Dunsbury Hill Farm
Transport Assessment Addendum
Portsmouth City Council

15th January 2013

This report has been prepared in response to comments received from Hampshire County Council (HCC) and the Highways Agency (HA) requesting additional information. Initial responses to the comments are presented in Appendix A.

Project:	Dunsbury Hill Farm - Stage 2
Subject:	Highways and Transportation – Comments from HCC and the HA and Atkins response
Date:	Nov 2012

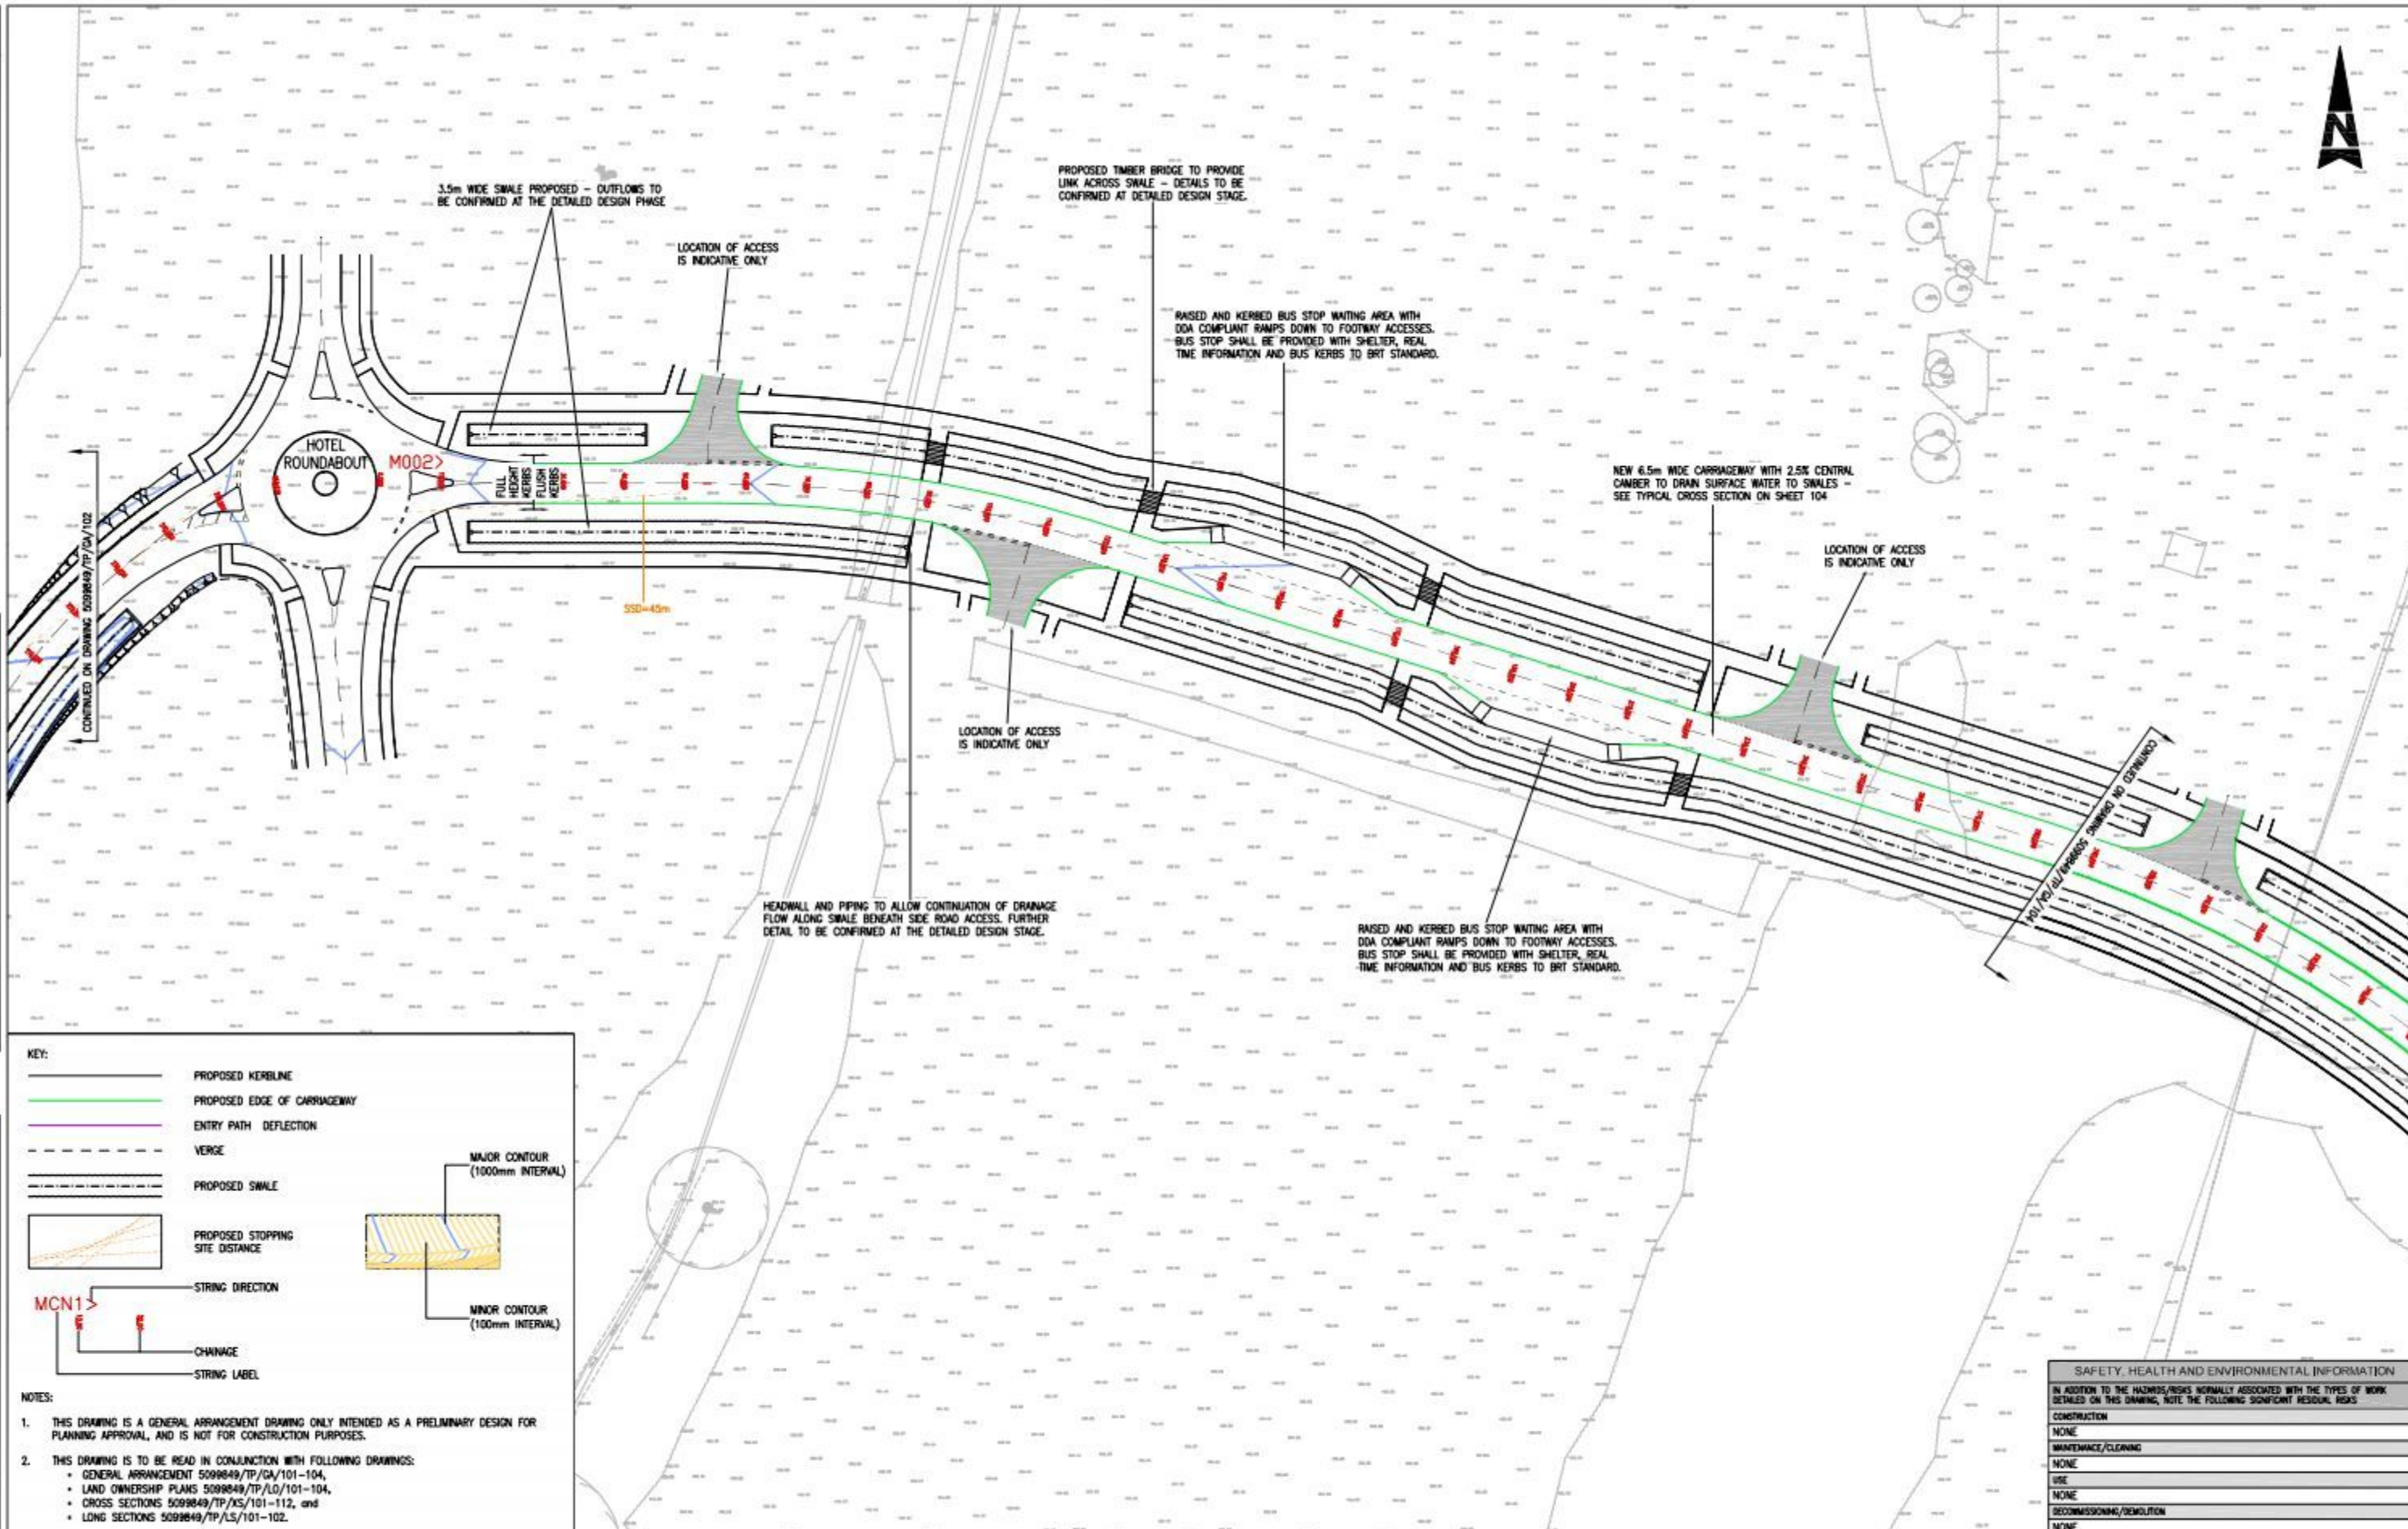
HCC SJ 08/12: "The need for pedestrian refuges on the link road as raised in my earlier letter have still not been added to drawing 103/Rev B. I still require this omission to be amended."

HCC SJ 08/12: "the pedestrian crossing facilities on hotel roundabout splitter islands have not been added to drawing 103/Rev B. I still require this omission to be amended."

HCC SJ 08/12: **"Drawing 103.** With regards to the Hotel roundabout.... the two entrances to the roundabout on both north and south shall be constructed to a minimum length of 45m to assure that the required visibility is provided.

- Annotation of drawing 5099849/TP/GA/103 Rev D to highlight that the proposed bus stops are to be constructed to BRT specification, including the implementation of:

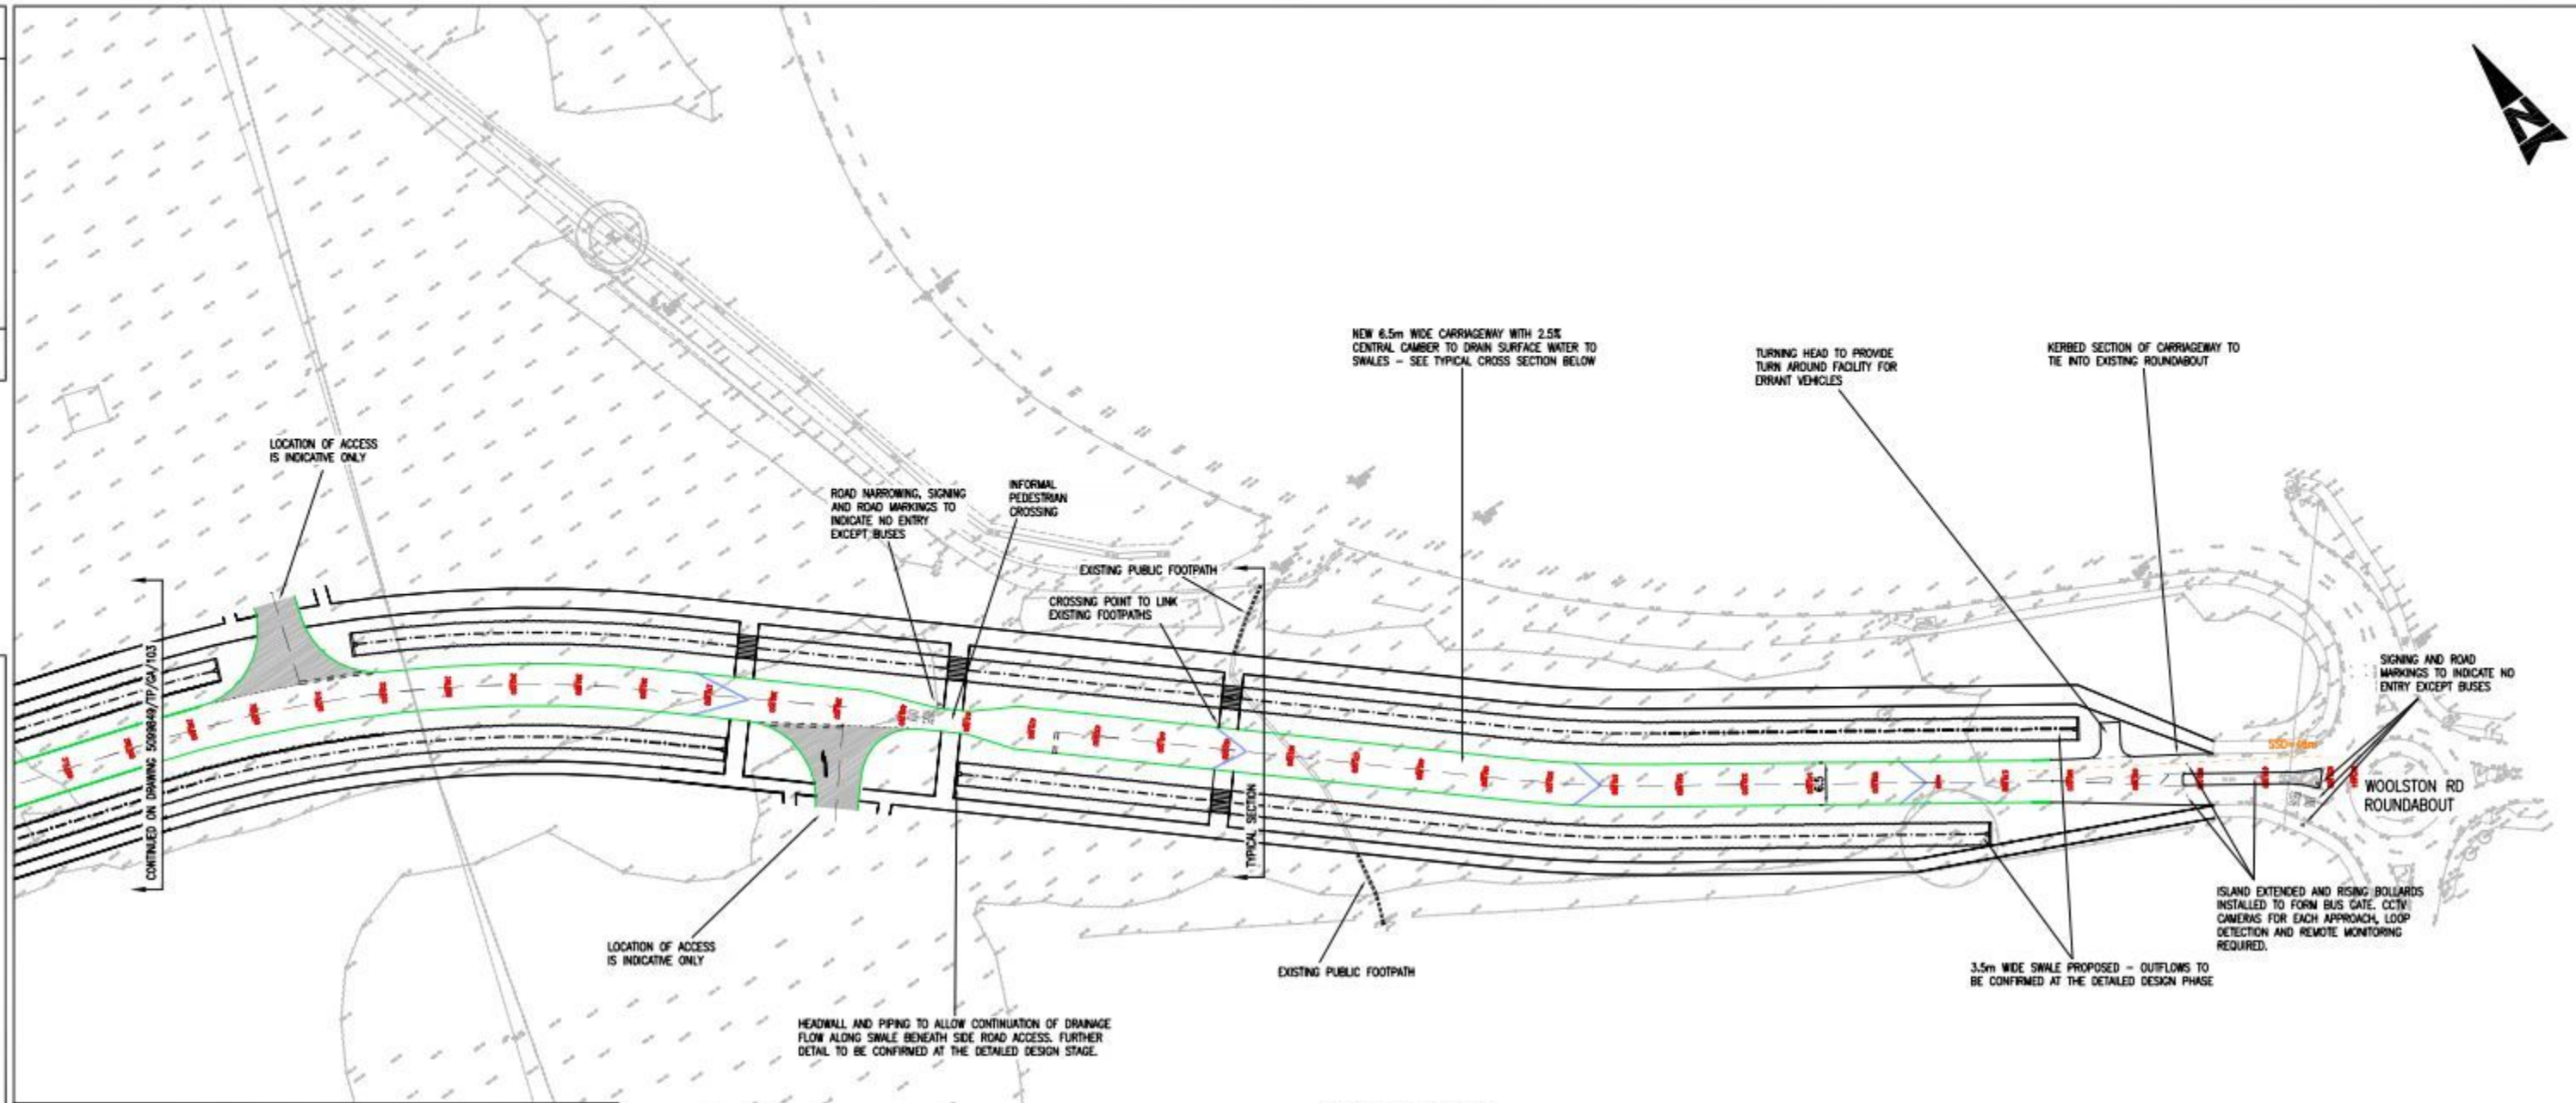
HCC SJ 08/12: **"Drawing 104.** The location of the CCTV cameras should be shown, it is suggested that these be placed on the nearside verges facing oncoming vehicles. An area of hard standing will be required for maintenance vehicles for the bus gate. Preferred location would be to the west of the bus gate. Appropriate signage and road marking should be considered to highlight the bus gate, with the possibility of red coloured surfacing."

HCC SJ 08/12: **"Drawing 104.** The rising bollards that enable the bus gate to be provided should be located a minimum of 25m from the roundabout 'Give Way' to allow for a bus to exit / enter the roundabout without encroaching on the bollard or the roundabout. Due to this the central island will need to be extended 5m beyond the bollard, thus the central island should be a minimum of 30m in length. Furthermore consideration should be given to preventing vehicles from mounting the footway and bypassing the bollard."

HCC SJ 08/12: **"Drawing 104.** The bus gate is situated approximately 200m from the nearest turning point on the western side, therefore any vehicle passing this turning will not be able to turn around when confronted by the bollard thus needing to reverse a considerable distance. Therefore it is necessary for a turning head to be provided for an appropriately sized vehicle. Consideration should be given to amending the geometry of the last access road to the west of the bus gate, this should be changed to effectively make the bus link the side road. This could be achieved through a combination of measures such as road

HCC SJ 08/12: **"Drawing 104. Vertical Alignment:** The applicant will need to consider the driveability of the vertical alignment on the southern approach to Hulbert Roundabout due to the undulating characteristic of the alignment and consider the eastern approach to the Hulbert Roundabout due to the steep incline. Some vehicles will need to stop on this incline and undertake a hill start which may not be ideal for some drivers. Therefore the applicant shall consider reducing the incline where possible as part of the Section 278 process."

HCC SJ 08/12: **"Drawing 104.** Drainage Proposals: the applicant shall provide all correspondence with the Environment Agency regarding the diversion works to Hermitage Stream, including flood risk analysis, all discharge consents that are required and the water quality report within a future submission."

HCC SJ 08/12: **"Drawing 104.** Street Lighting Proposals: Maintenance numbers of all existing street lighting furniture, including illuminated signs and bollards shall be provided at the detail Section 278 stage."

- Relocation of the proposed rising bollard further west to provide a distance of 20 metres between the Woolston Road roundabout and the bollard. The central traffic island has been extended to the west to match the new position of the rising bollard;

- Narrowing of the link road carriageway to 3.5 metres at the western end of the bus only section to more clearly define the bus only section. Associated with this measure is the implementation of give way markings on the westbound approach to the narrowing to give priority to eastbound buses. It is also proposed to provide an informal pedestrian crossing point at the narrowing; and
